**ADDENDUM NO. 1**  
to the  
**Iowa Department of Transportation**  
**Proposal No. 14842**  
**For: Electrical Upgrade for Newton Maintenance Garage**  
**Letting Date: 8/19 /2015**

**ADDENDUM #1  
ELECTRICAL ITEMS**

**PROJECT:** Iowa Department of Transportation  
Maintenance Facility Electrical Upgrade  
Newton, Iowa  
ME Project #1234

### 1 CT CABINET/METER SUPPORT STAND DETAIL

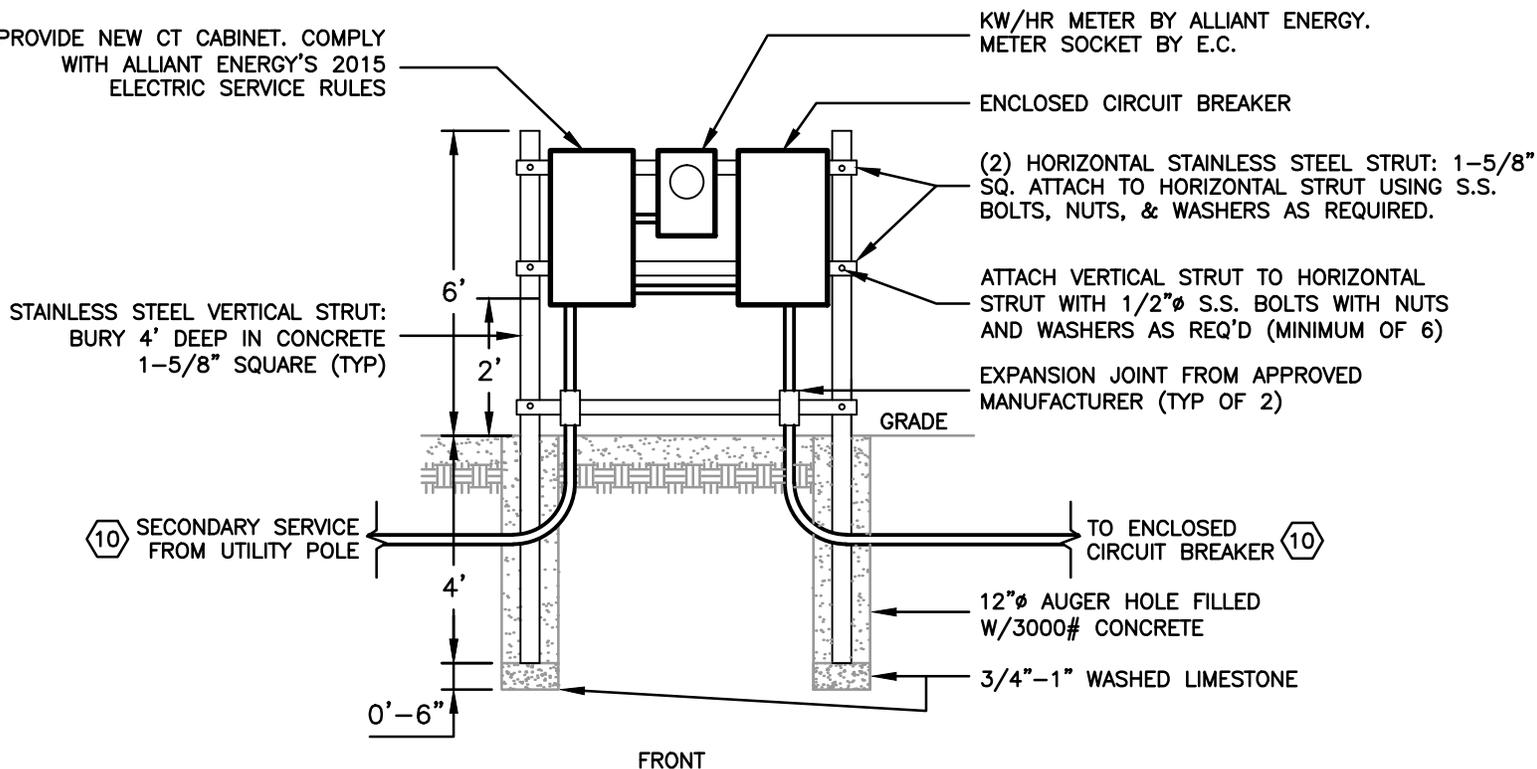
1. Sheet E1 – Electrical Site Plan  
Add the attached detail (Attachment A) to sheet E4.  
Demolish existing kw/hr meter and main switch on existing utility pole. Provide a CT cabinet, kw/hr meter socket, and an enclosed circuit breaker on a stainless steel strut stand adjacent to the existing utility pole. Move the enclosed circuit breaker from position shown next to Panel P1 on the generator pad to new location; reduce the size of that stand to accommodate Panel P1 only. Refer to attached detail for additional information. Provide metering wiring in a ¾” rigid galvanized steel conduit between the CT cabinet and meter socket. Comply with Alliant Energy’s 2015 Service Rules for the CT cabinet, metering circuits, and meter socket. Coordinate all electric utility related work with Alliant Energy.

PROVIDE NEW CT CABINET. COMPLY WITH ALLIANT ENERGY'S 2015 ELECTRIC SERVICE RULES

KW/HR METER BY ALLIANT ENERGY.  
 METER SOCKET BY E.C.

ENCLOSED CIRCUIT BREAKER

(2) HORIZONTAL STAINLESS STEEL STRUT: 1-5/8" SQ. ATTACH TO HORIZONTAL STRUT USING S.S. BOLTS, NUTS, & WASHERS AS REQUIRED.

ATTACH VERTICAL STRUT TO HORIZONTAL STRUT WITH 1/2"φ S.S. BOLTS WITH NUTS AND WASHERS AS REQ'D (MINIMUM OF 6)

STAINLESS STEEL VERTICAL STRUT:  
 BURY 4' DEEP IN CONCRETE  
 1-5/8" SQUARE (TYP)

12"φ AUGER HOLE FILLED W/3000# CONCRETE
